Parcel 42 (Hope Point Tower) Concept Plan Summary

I-195 Redevelopment District Commission Meeting
January 18, 2023

Concept Plan Design Review Comments, Waivers, and Amendments

Updated Ground Floor Plan

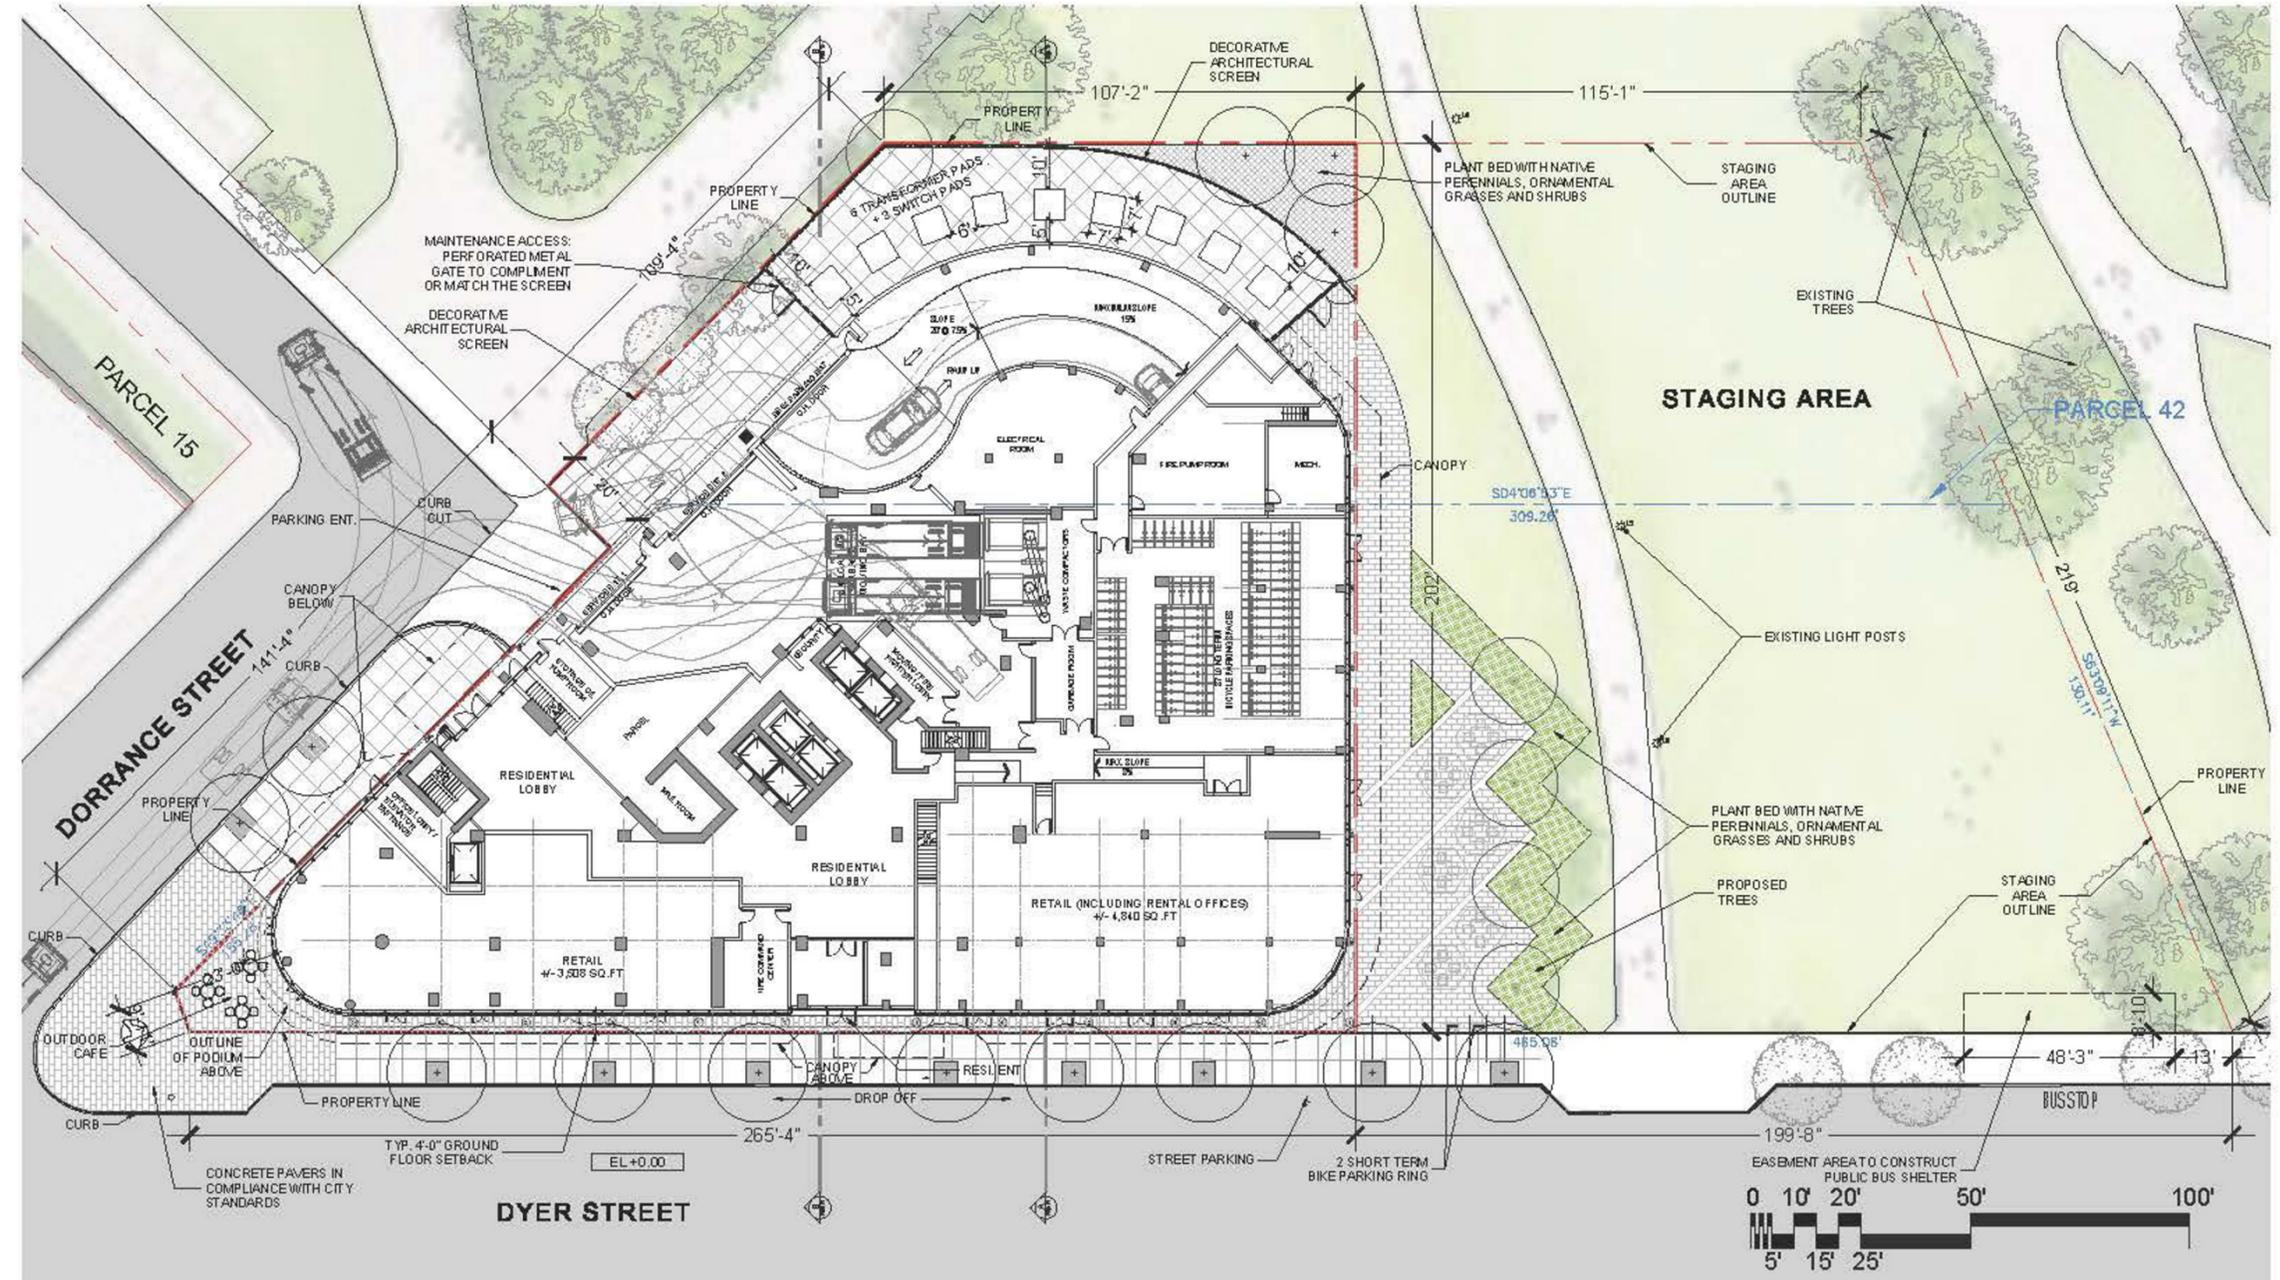
- Access to both the loading dock and parking garage is via a driveway that parallels the Dorrance Street park path.
- Eight transformers define the eastern edge of the building and would be highly visible from the park.

Design Evolution

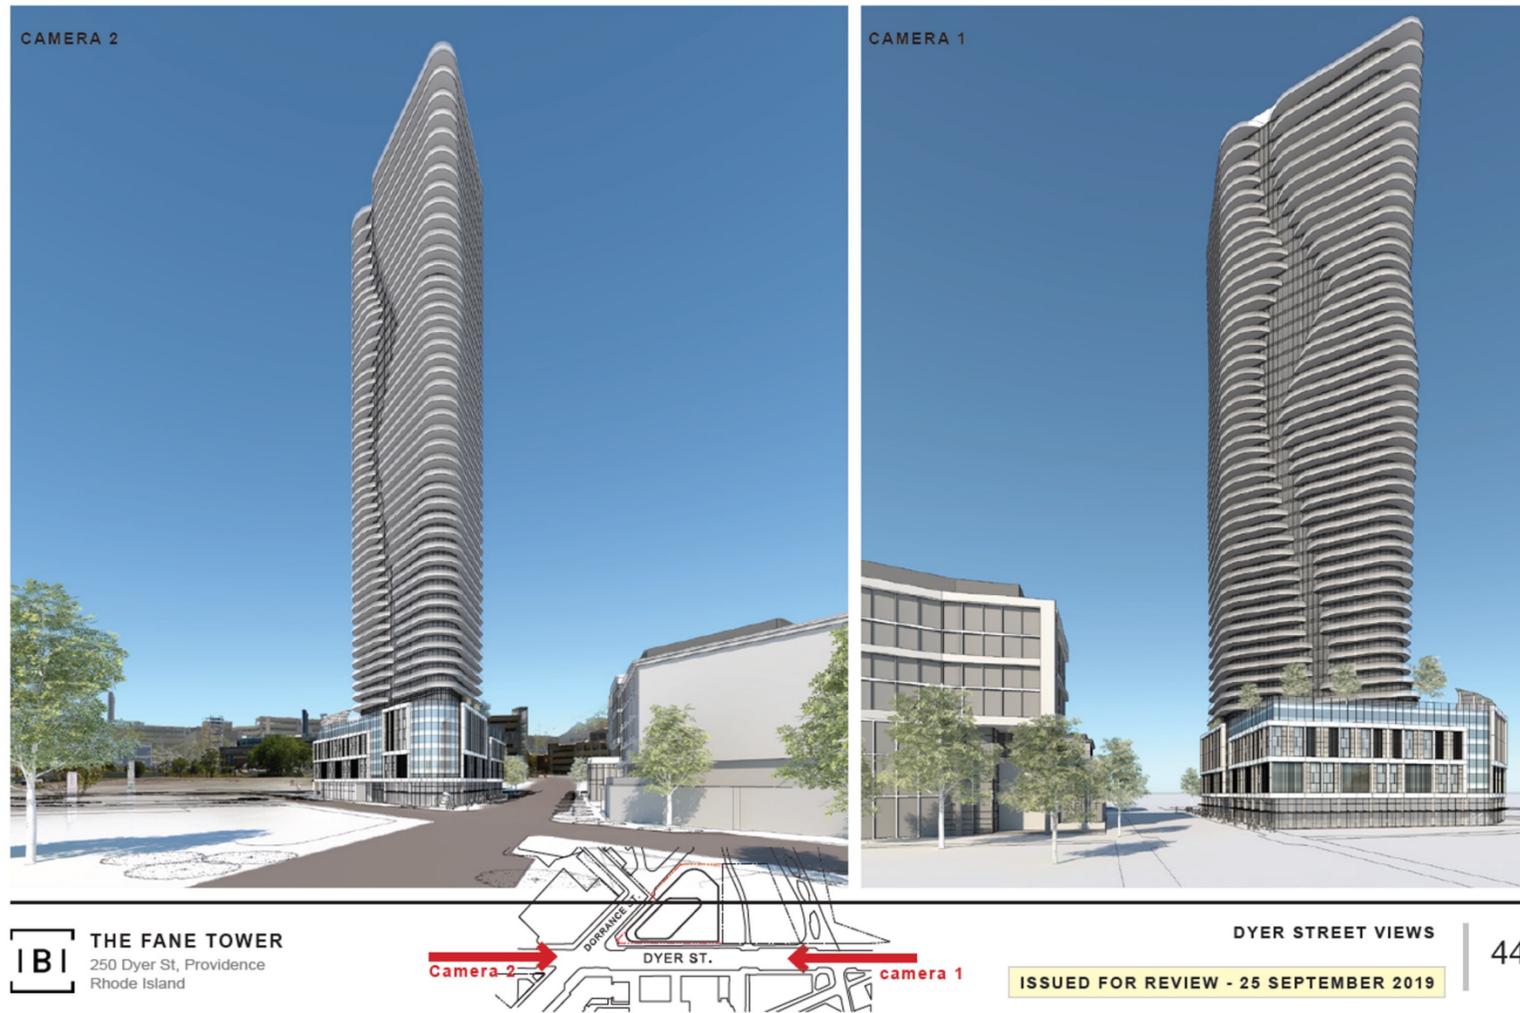
The height of the podium/base has been reduced from six to four stories and the architectural expression has been simplified.

Design Evolution

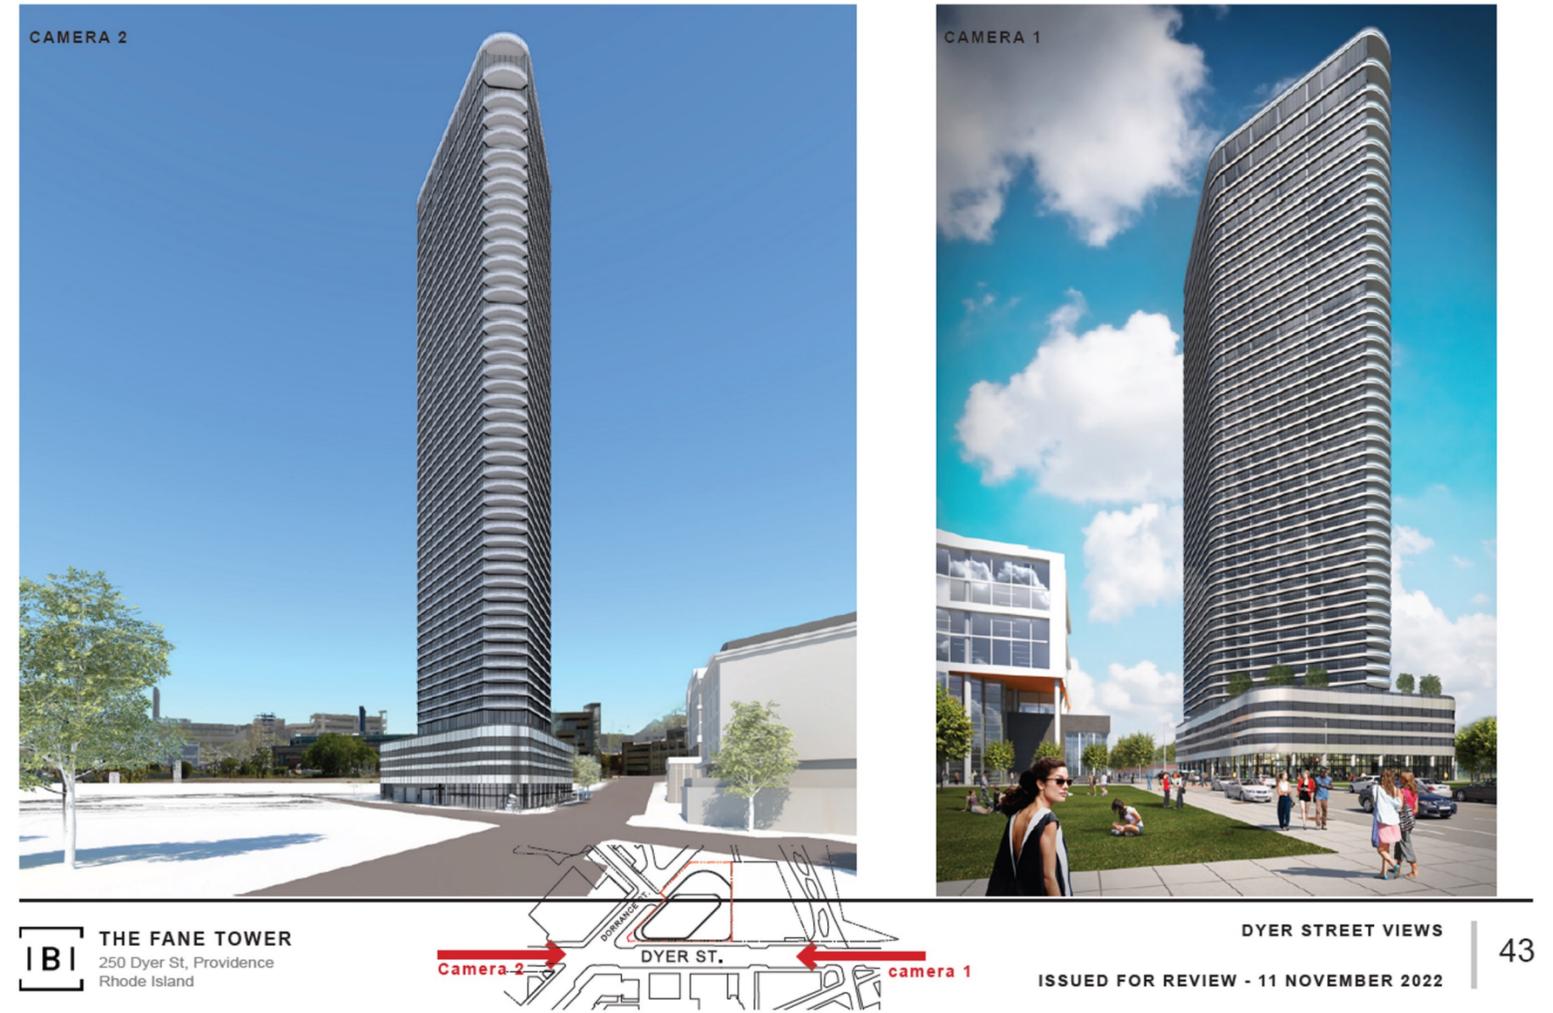
The sculptural balconies have been eliminated and the relative proportion of the tower and podium has been changed (with reduction of the podium from six stories to four stories)

VIEW FROM PARK TOWARDS WEST

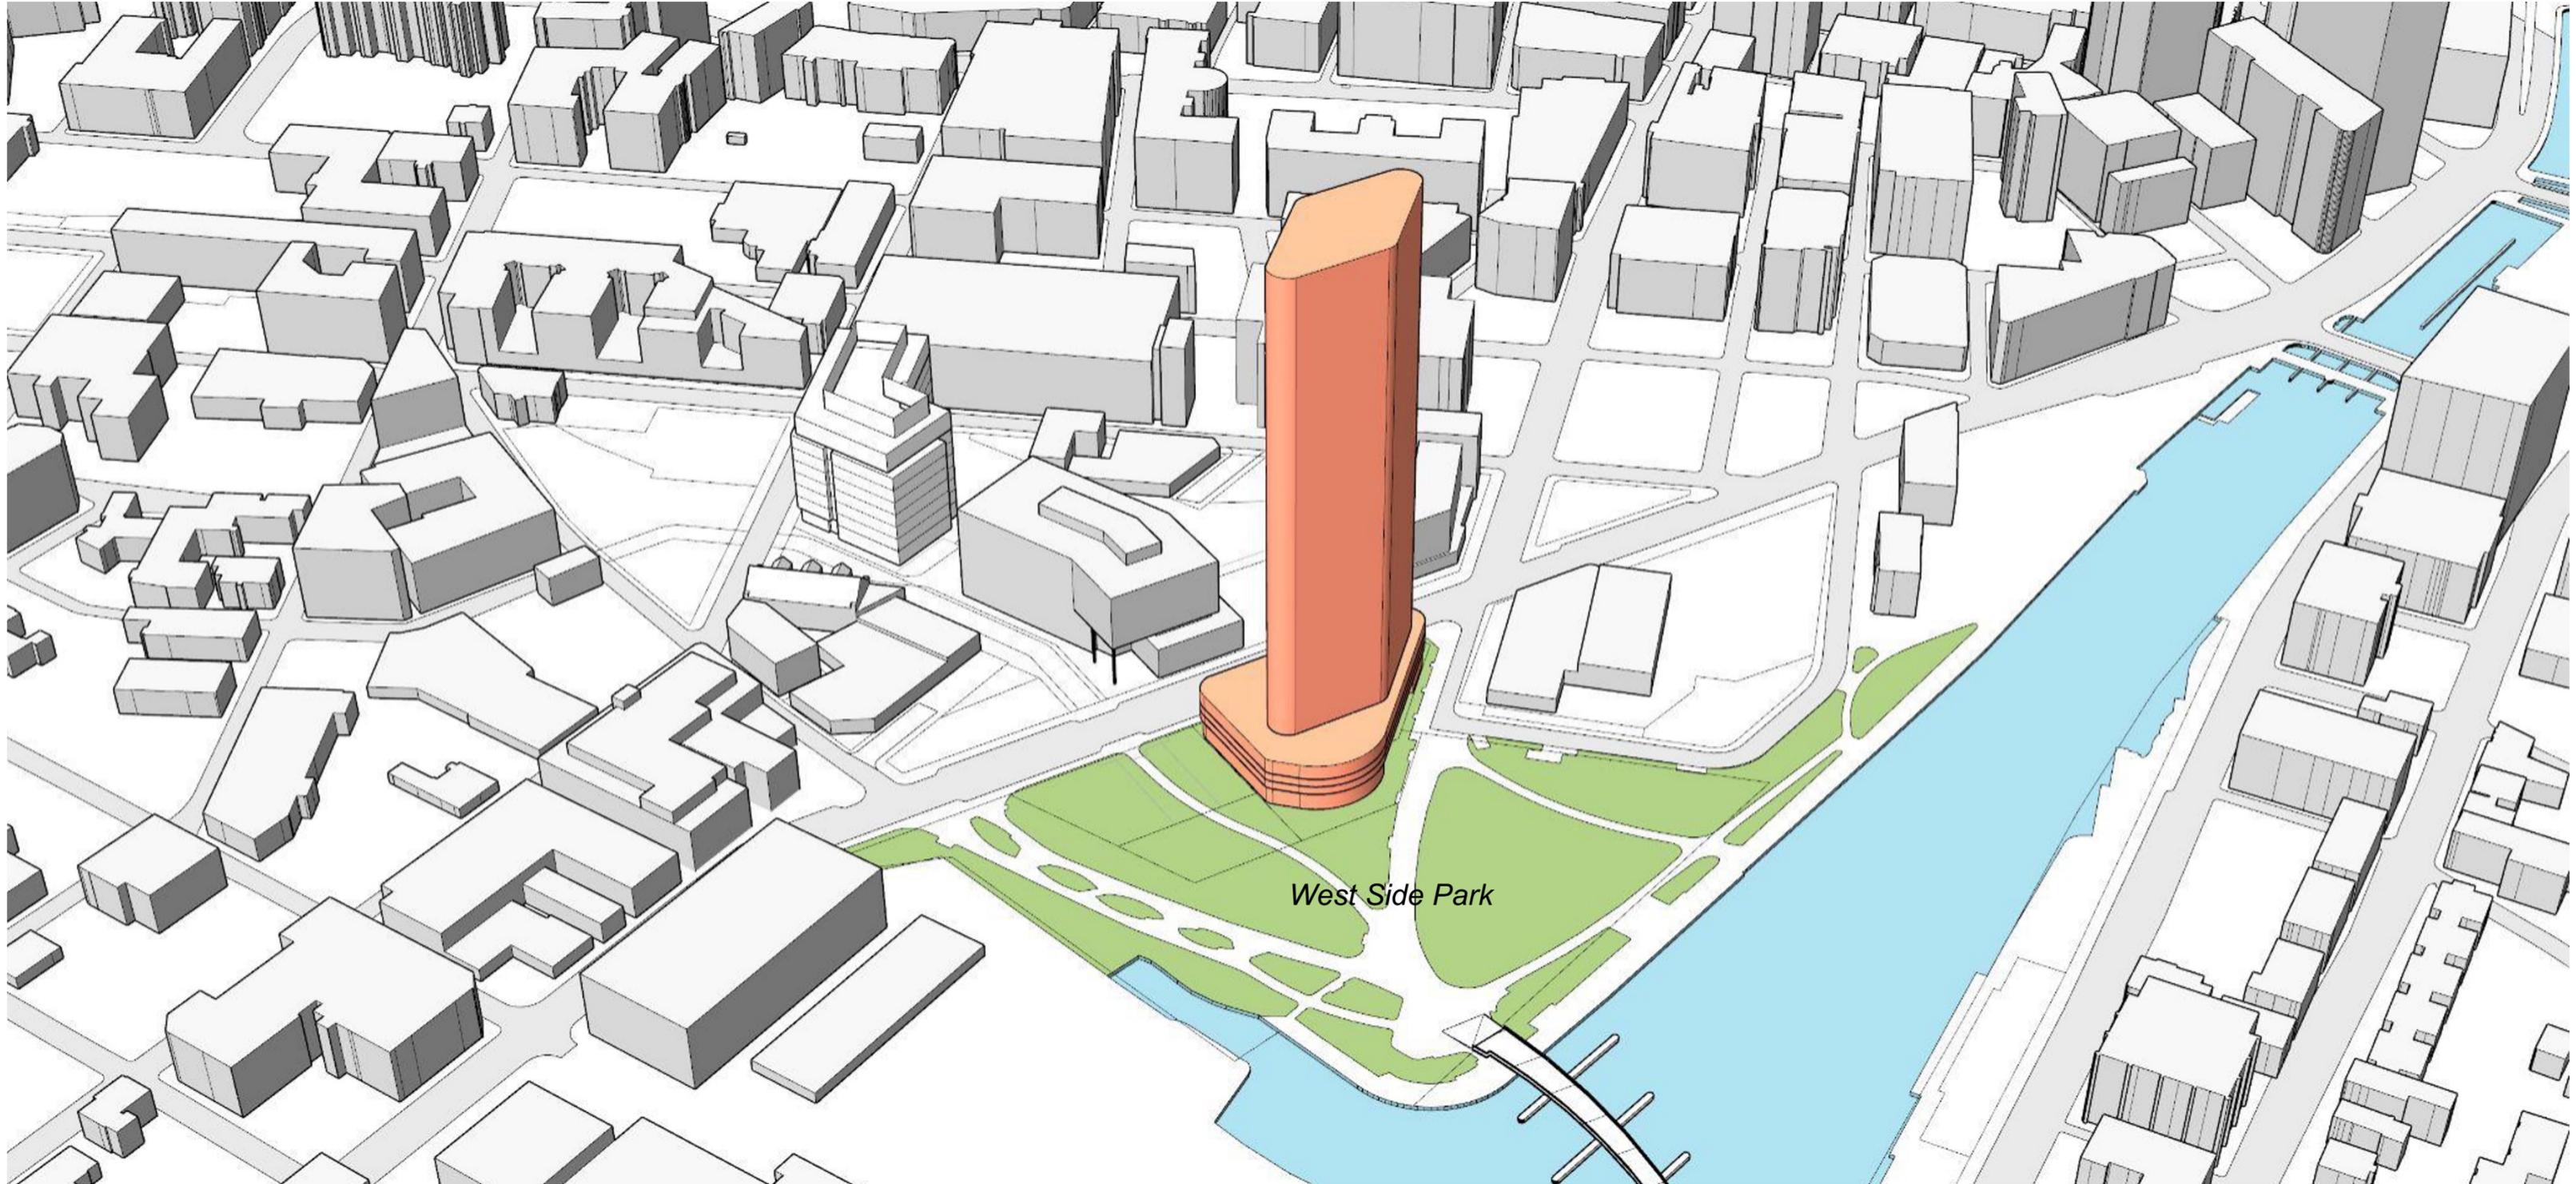
The sculptural balconies have been eliminated and the relative proportion of the tower and podium has been changed (with reduction of the podium from six stories to four stories)
